SOLICITATION AMENDMENT

Title - Sujet High Pressure Air Test Facility Upg	
Solicitation No. - N° de l'invitation EB144-172513/A	Amendment No. - N° modif. 004
Client Reference No. - N° de référence du client EB144-17-2513	Date 2017-03-28
GETS Reference No. - N° de référence de SEAG PW-\$PWA-405-5531	
File No. - N° de dossier PWA-6-76133 (405)	CCC No./N° CCC - FMS No./N° VME
Solicitation Closes - L'invitation prend fin at - à 02:00 PM on - le 2017-04-04	Time Zone Fuseau horaire Atlantic Daylight Saving Time ADT
F.O.B. - F.A.B. Plant-Usine: <input type="checkbox"/> Destination: <input checked="" type="checkbox"/> Other-Autre: <input type="checkbox"/>	
Address Enquiries to: - Adresser toutes questions à: MacDonald (PWA), Ashley	Buyer Id - Id de l'acheteur pwa405
Telephone No. - N° de téléphone (902) 496-5291 ()	FAX No. - N° de FAX (902) 496-5016
Destination - of Goods, Services, and Construction: Destination - des biens, services et construction:

PROJECT: D-200 HIGH PRESSURE AIR TEST FACILITY
PROJET: CFB HALIFAX, BLDG D-200, NS

SUBJECT: DEMOLITION HIGH PRESSURE AIR
SUJET: TEST CELL

MSK-01

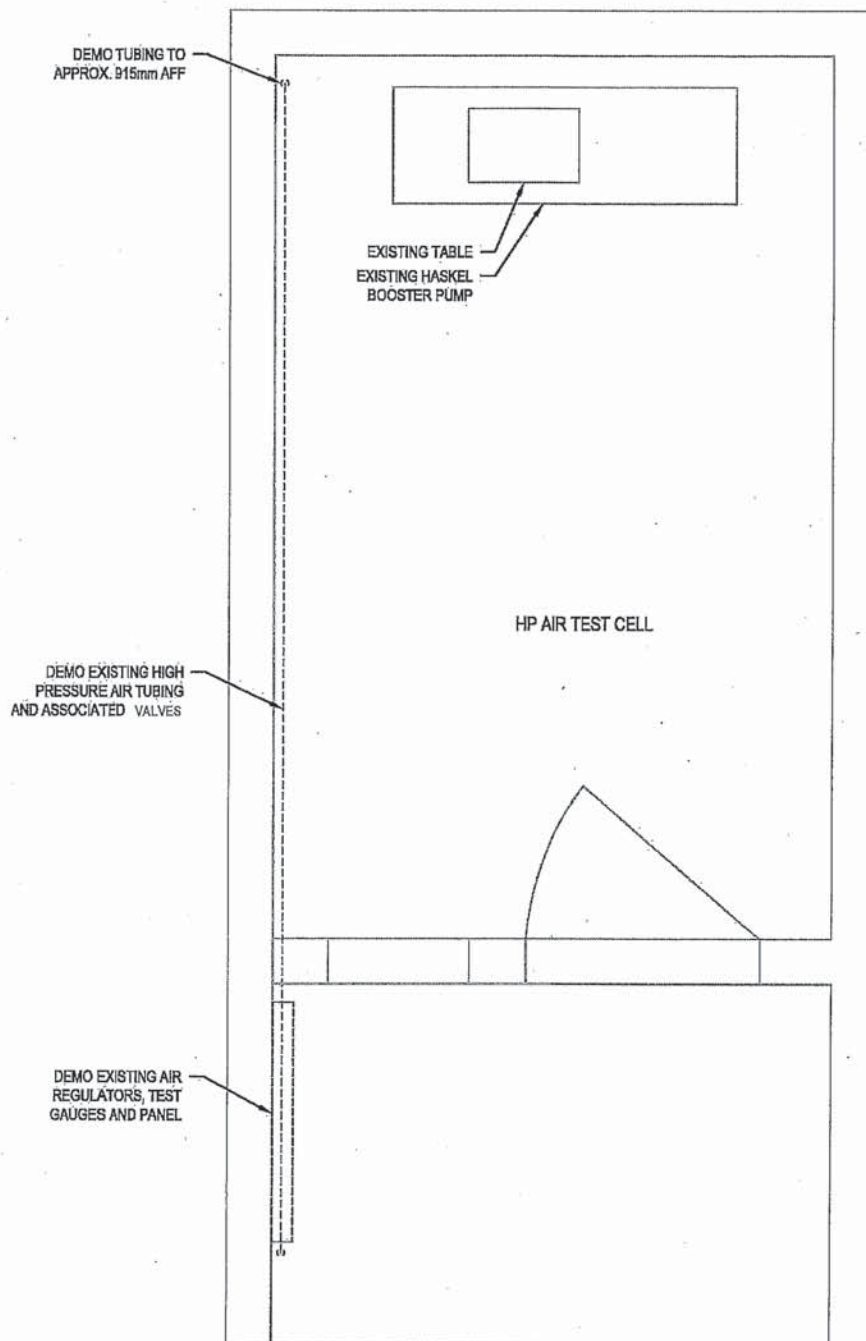
1. **Reference Drawing M401 – Floor Plan, Details and Notes :**
 - .1 Add detail 2/401 Demolition High Pressure Air as shown on MSK-01.
2. **Reference Drawing M403 – Mechanical Flow Diagrams, Bill of Materials and Legend:**
 - .1 REPLACE drawing with revised M403. (Attached)

REFER TO DETAIL 2 ON DWG 401
